CRC264624, 625, 627, 628 and 629; response to request for further information

Thank you for your request for further information dated 1 July 2026 (the RFI, copy attached to this letter as Attachment 1). This letter responds to the RFI. Each question and response is provided in a two-cell table, with the question in italics in the first cell, and the response (with quotes, if provided, in italics) in the grey-shaded second cell.

14. Works on Section 10 Seaforth SETT

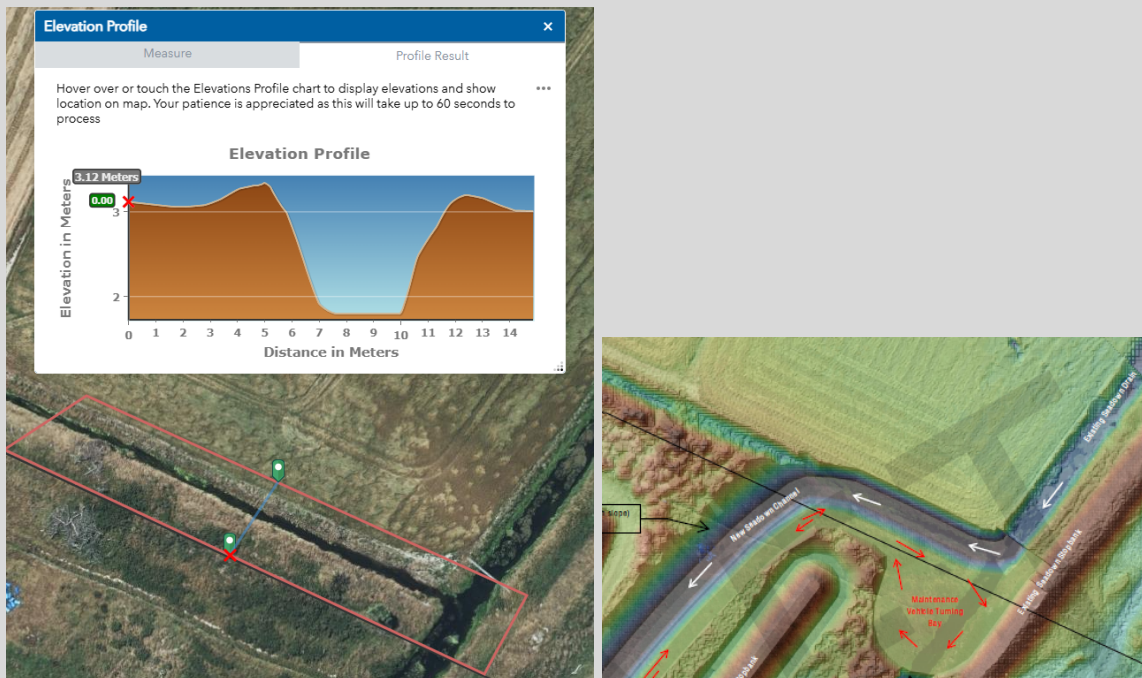
- a. Please clarify the nature and extent of works required within No.2 drain on this property.
- b. Does Environment Canterbury have any authority available to complete these works, for example under an easement or other permission?

No. 2 drain is the applicant's asset and runs parallel to the property boundary, with its true left bank set into the neighbouring property approximately 12 metres and the true right bank approximately 5 metres inside the boundary (refer left hand figure below). The proposal is to increase the capacity of the section of No. 2 drain between the new alignment and Seadown drain (right hand figure below). This work will only occur over the existing footprint of No. 2 and toward the property boundary so that there is no impact to productive land. On that basis, potential effects on the land owner are considered to be less than minor, and the land owner is not considered to be an affected person.

c) Maximum velocity – existing situation (Fig 13b)

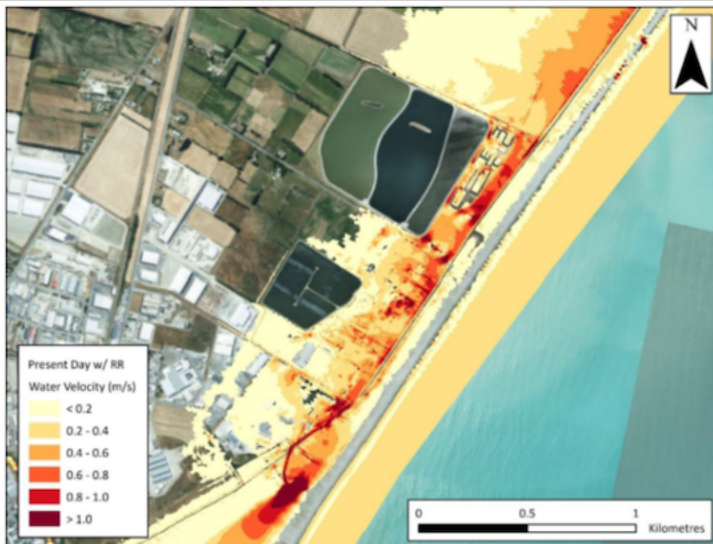
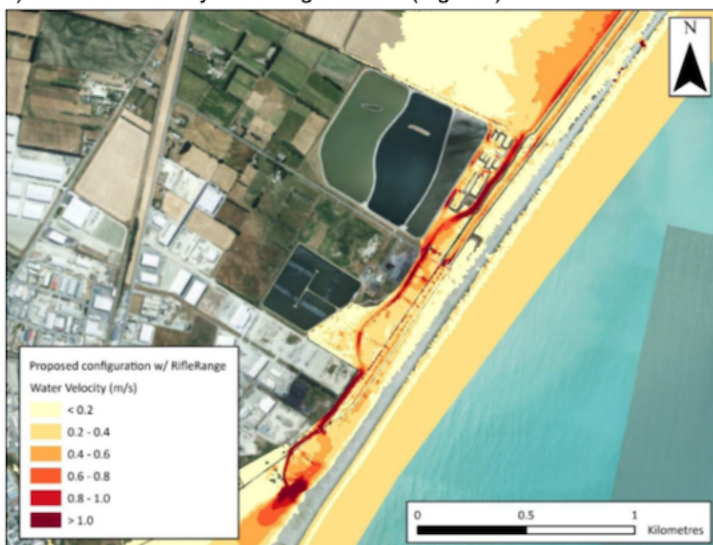
a. Please provide an assessment of the activity against Rule 5.142 of the LWRP.

Under the existing situation, flood water from the Ōpihi River breakout, or a large rainfall event, is channelled on the inland side of the existing coastal stopbank. This situation will continue after the realignment, and the inland bank is proposed to mitigate potential flooding effects on the neighbouring industrial land. This could be considered as alleviating surface flooding.

Therefore, to be conservative, it is accepted that Rule 5.142 could apply once the realignment is complete.

With regard to condition a of Rule 5.142, flood waters from an Ōpihi River breakout predicted to have low velocity, and low erosion risk. It is not considered that this condition is breached. Figure 28 c and d of the consent application (copied below) show the modelled velocities for the exiting situation proposed situations and indicate:

- 1) That the absolute velocities are not high, with the “greater than” category being 1 metre per second.
- 2) That the difference between the situations is less to do with absolute velocity than with channelling of higher speed flows in the new drain alignment

Figure 8: SMA – Hilton Haulage – vehicle collision storage yard.

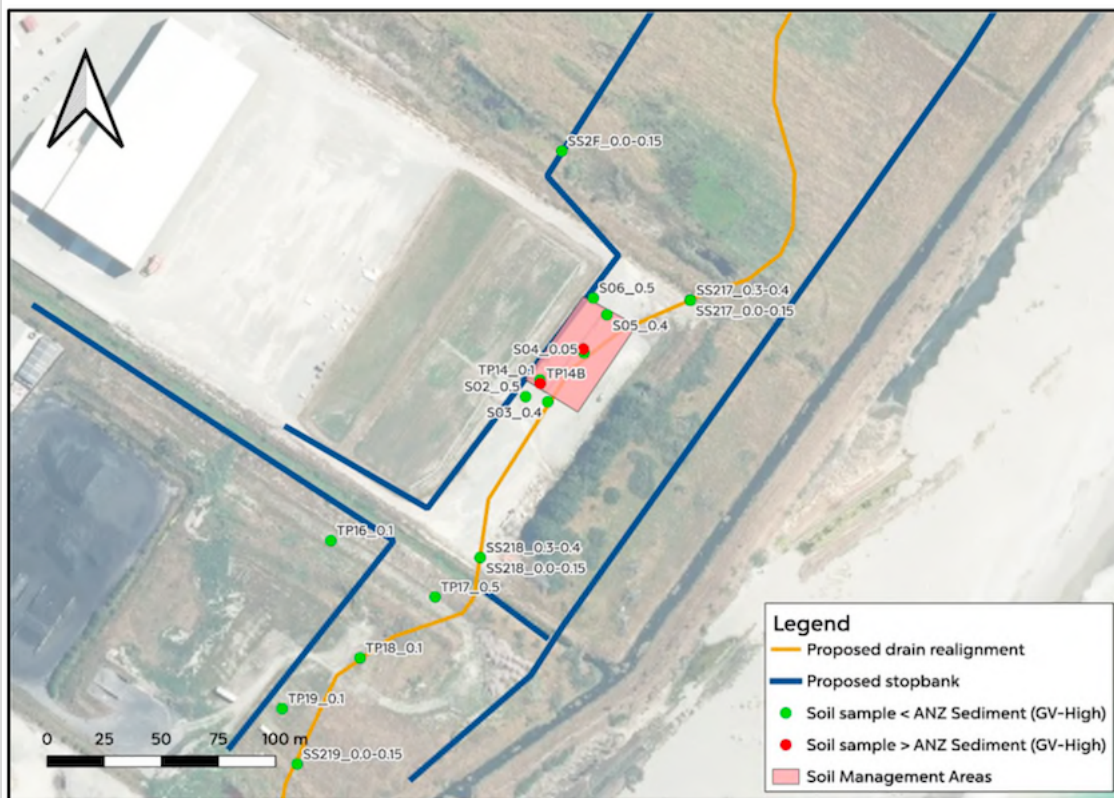
b. Please clarify whether contaminant soils are proposed to be encapsulation on site. If so, please provide:

At present, the only soils known to require encapsulation are located at the Hilton Haulage Limited damaged vehicle yard, where a thin layer of soil contaminated with hydrocarbons and metals has been identified (CLMP figure 8 copied below shows that location). This material has an estimated volume of 176 m³ and while a final location for its deposition has not been decided, two possible locations are identified but are subject to landowner approval (CLMP figure 12, copied below).
